TRANSMITTAL OF THE FINAL TECHNICAL MEMORANDUM NO. 1, MONITORED NATURAL ATTENUATION OF IHSS 118.1, REV. 1 - JEL-130-98

FINAL TECHNICAL MEMORANDUM NO. 1

MONITORED NATURAL ATTENUATION OF IHSS 118.1

Response to Colorado Department of Public Health and the Environment Comments on the Final Technical Memorandum No. 1, Monitored Natural Attenuation of IHSS 118.1

IHSS 118.1 Location Map
Boreholes, Wells & Tank Locations
 (Including Utilities for Area
 except Alarms & Communications)

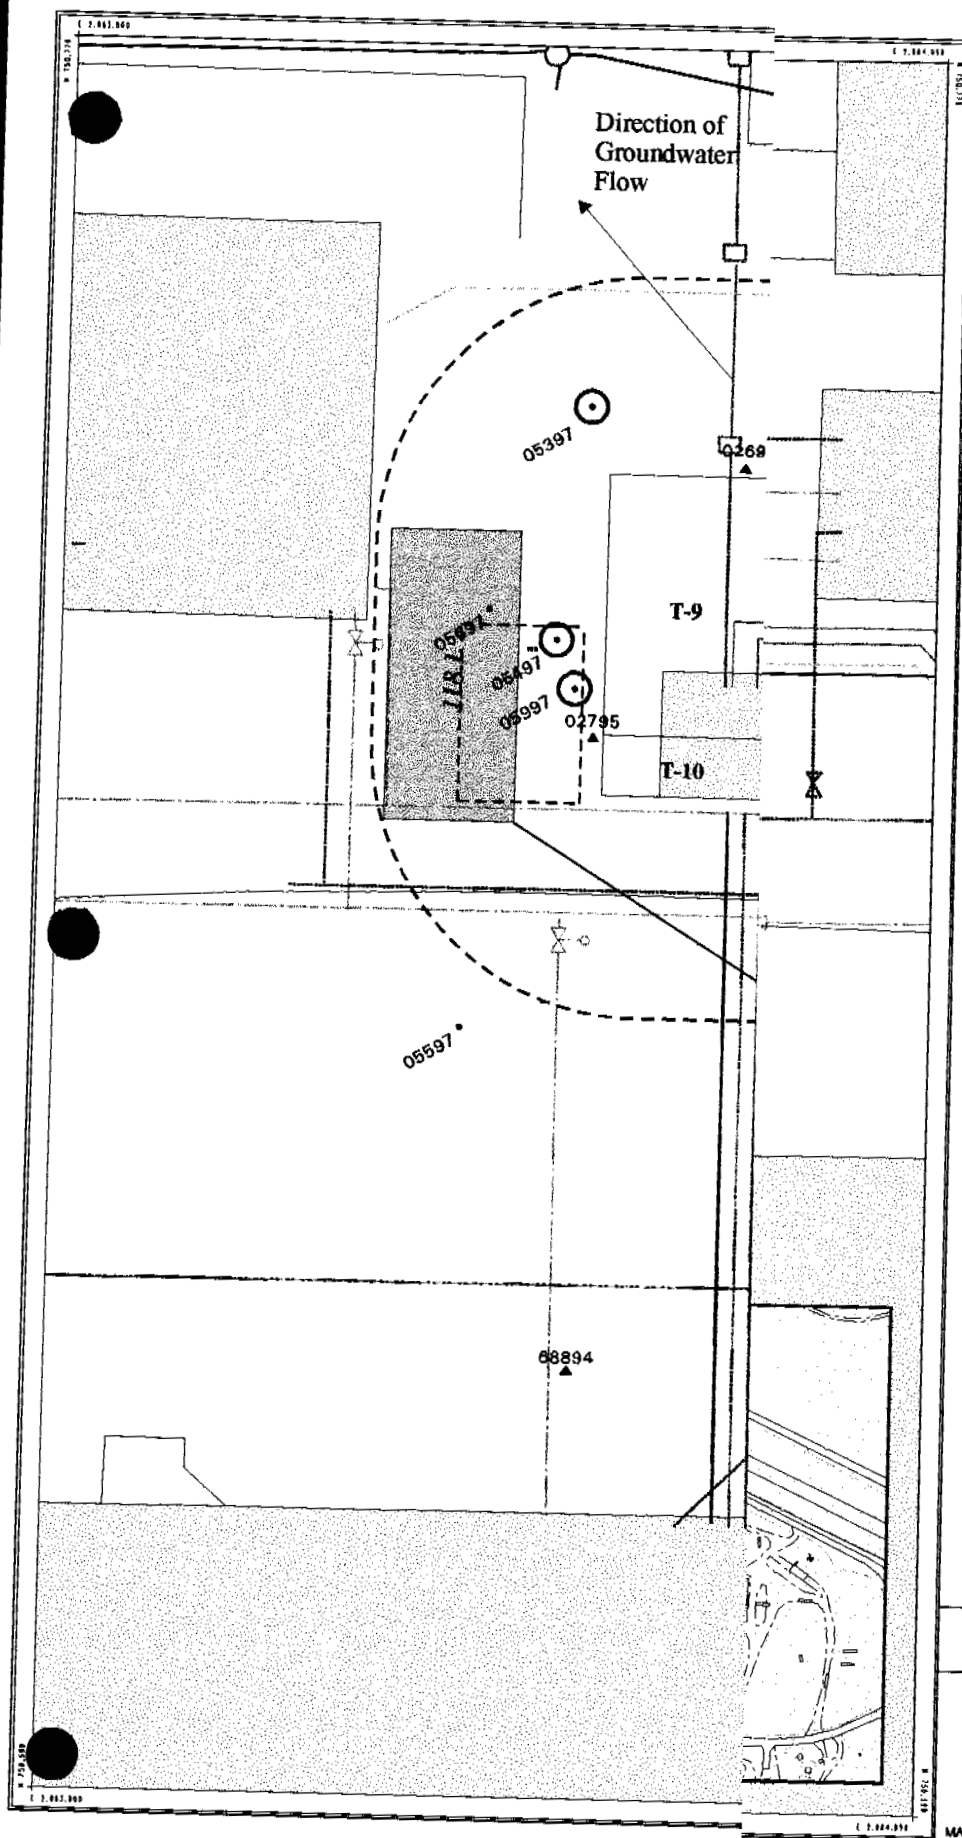
2. In addition to Figure 2-5, a local top of bedrock map or a north-south cross section would be useful to illustrate the excavation area in the direction of groundwater flow.

Response: *The extent of the excavation and the direction of ground water flow have been added to Figure 2-1. At this time there is no information on the top of bedrock contour between IHSS 118.1 and Building 771. The core logs from installation of the proposed monitoring wells north of IHSS 118.1 should provide the information to make a north-south cross-section that extends north to Building 771.*
